## Urgent Field Safety Notice

**Apollo**  
**FSCA-2016-01-15**  
**Additional directions for a safe use of the device.**

Apollo, Apollo DRF, Apollo EZ, Apollo EZ DRF tables, all serial numbers

2. Where to apply the provided labels

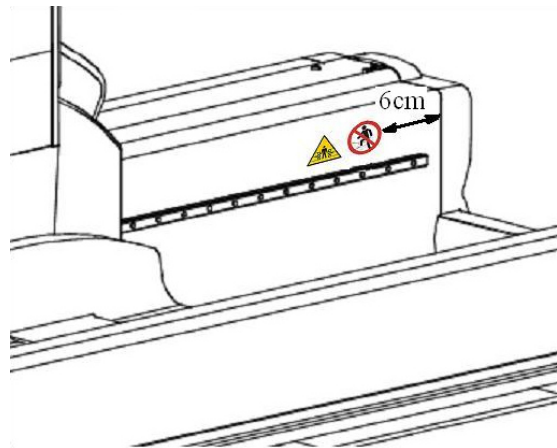
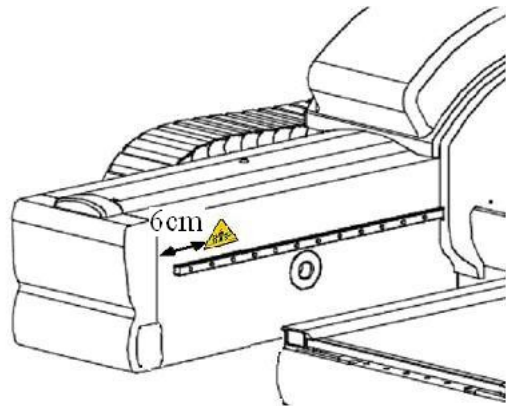
<p>left side labels:</p>		<p>For Apollo OPEN version, as there is no arm in left side, remove prohibition symbol and apply only warning symbol</p> 
<p>right side labels:</p>		
<p>additional directions supplementing the IfU and the Technical documentation already supplied with the device</p>
